SERVICE BULLETIN NO. 116

Check Valve

For Visual Cooking model 1.20 CombiClean, we have introduced check valve No. 20500158, the purpose of which is to ensure that the detergent from the upper jet does not run back. The location of the valve is as shown below.

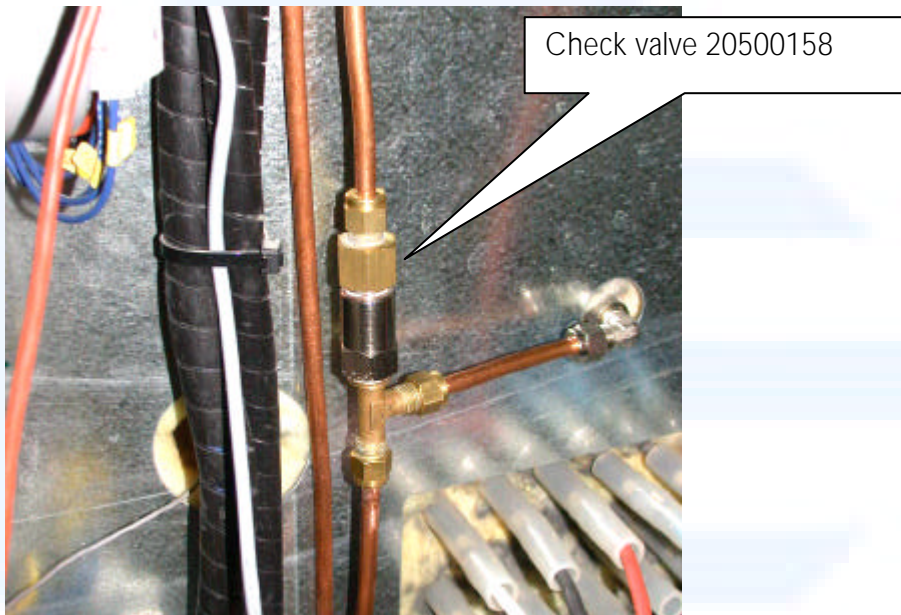
The upper jet is located so that detergent is sprinkled upwards towards the roof, the lower jet so that water is sprinkled downwards.

The new valve was introduced on 1st April 2005
